STAFF REPORT

NOLL POINTE PLANNED RESIDENTIAL DEVELOPMENT AND PRELIMINARY SUBDIVISION

To: Planning Commission
From: Edie Berghoff, Senior Planner
Date: June 16, 2026
Subject: Noll Pointe Planned Residential Development and Preliminary Subdivision | Type III Application

Proposed PRD & Preliminary Plat (Exhibit C, sheet C1.00):

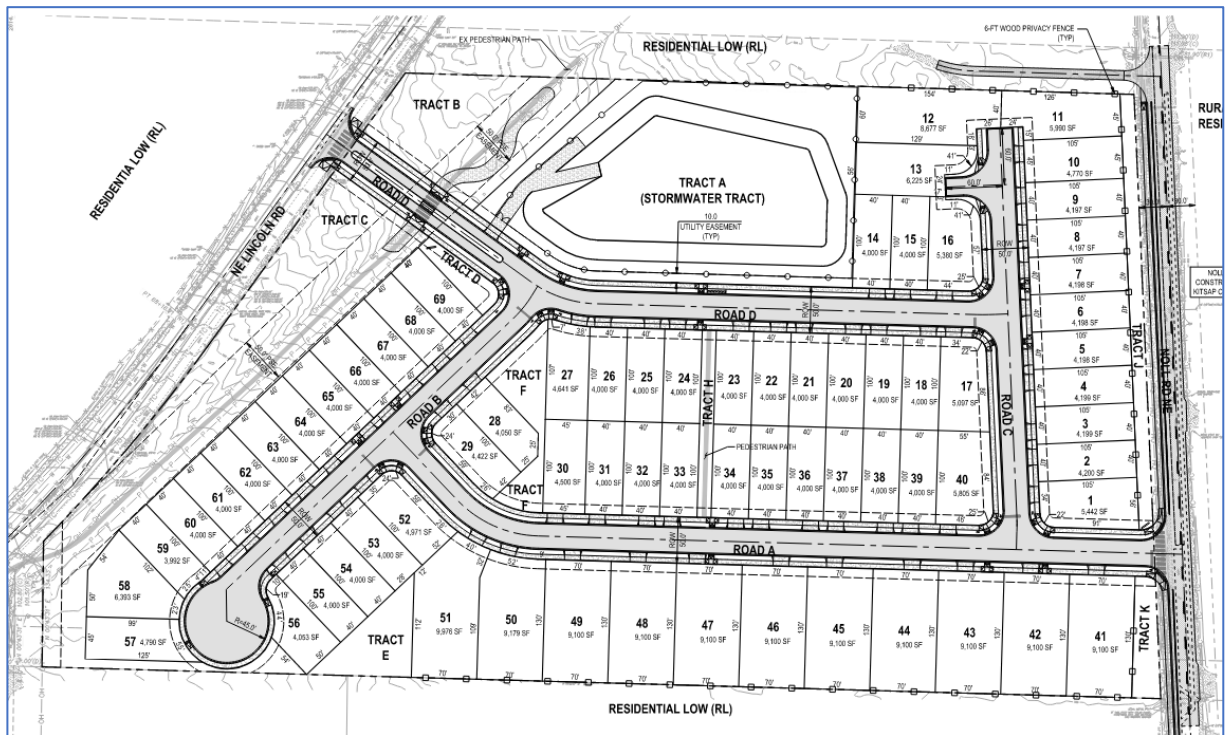
Staff Comment. As reviewed and conditioned, the proposed preliminary subdivision conforms to the requirements of Title 17, Land Division. The City Engineer has reviewed the project for consistency with [Chapter 12.02](#), Construction and Development Standards, and supports approval of the preliminary subdivision subject to all conditions of approval. See also Exhibit C, Engineering Department SEPA Memo.

Hydric Soils and Delineated Wetlands
Land Use Comprehensive Plan, Figure NE-1

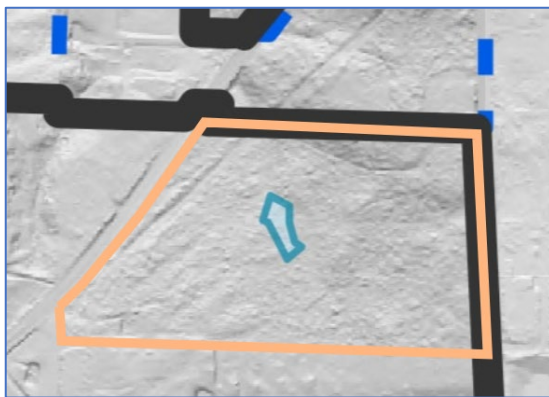
The City's Hydric Soils and Delineated Wetlands map (Land Use Comprehensive Plan, Figure NE-1) identifies a mapped wetland near the center of the subject property (as shown below). The City's Fish and Wildlife Habitat Conservation Areas map (Land Use Comprehensive Plan, Figure NE-4) identifies a mapped stream extending from the center of the site to the northwest (as shown below). These mapped resources are intended for planning purposes and do not replace site-specific critical area review conducted in accordance with PMC Chapter 16.20.

Staff Comment. Based on the submitted critical areas report, supplemental technical memoranda, and independent peer review, staff finds that no wetlands, streams, fish and wildlife habitat conservation areas, or associated regulatory buffers are present on the subject property. Although historical mapping and previous investigations identified a wetland and seasonal drainage feature, current investigations conducted using updated methodologies do not support the presence of regulated critical areas onsite. The proposal therefore complies with the applicable provisions of PMC Chapters 16.20.200 and 16.20.300.

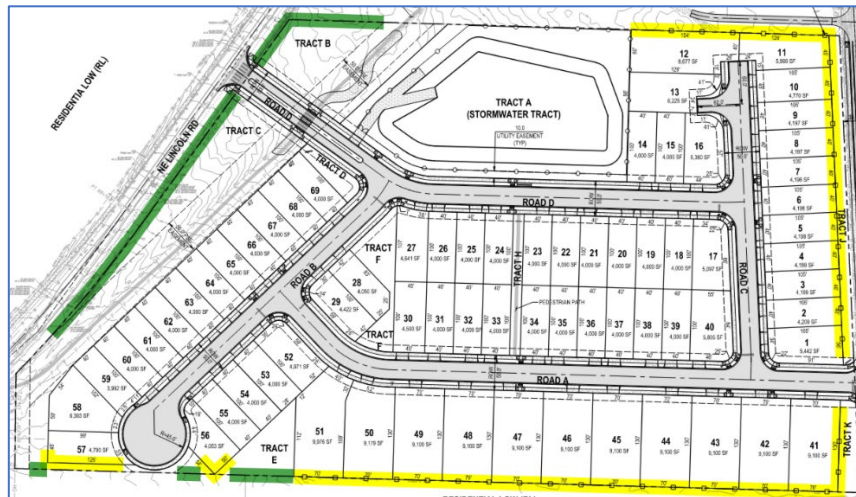
Staff Comment. Noll Valley Park, a traditional city subdivision, is immediately adjacent, south, of the proposal. Lots 41 through 51 in Noll Pointe are adjacent to lots in Noll Valley Park. Within the two developments abutting lots lot sizes are similar, typical lot width is 70 feet and typical lot depth is 130 feet. Homes in Noll Valley Park are two stories and homes in Noll Pointe are proposed to be two stories. No attached units are proposed in Noll Pointe.

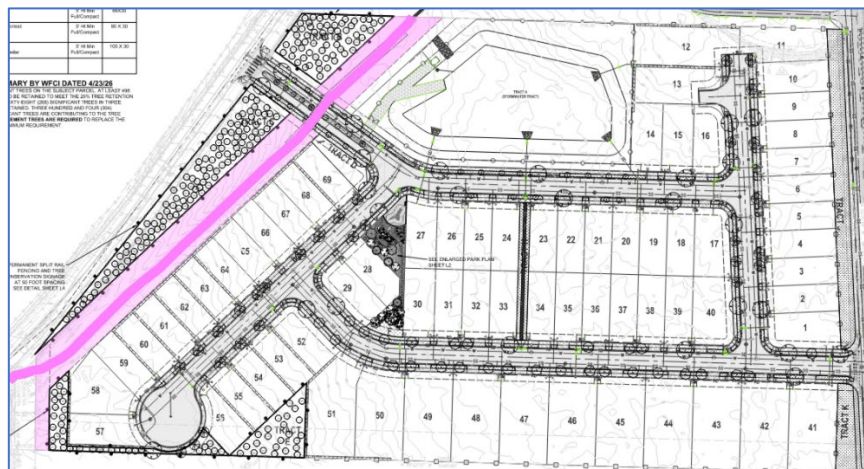
Staff Comment. Open space is provided for the occupants of the PRD. An approximately 800-foot pedestrian trail located within the powerline corridor will be formalized through the project's open space tracts and dedicated for public access. (COA P47 and P58).

(Source Landscape Plan, sheet L1)

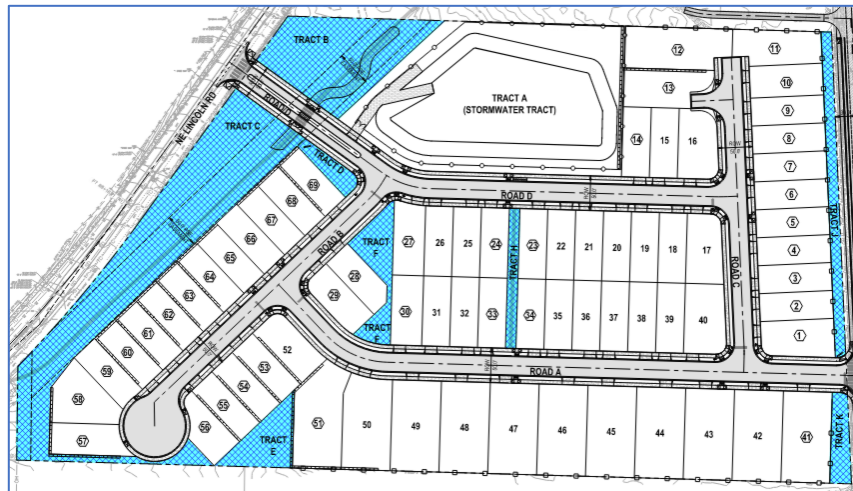
Staff Comment. Open space is visible to 40 of the 69 lots and easily accessible to all residents via sidewalk and off-street pathway. Improved, natural and landscaped open areas are located throughout the project. Tree retention along Lincoln Road and pockets at south project boundary provide natural and planted open space.
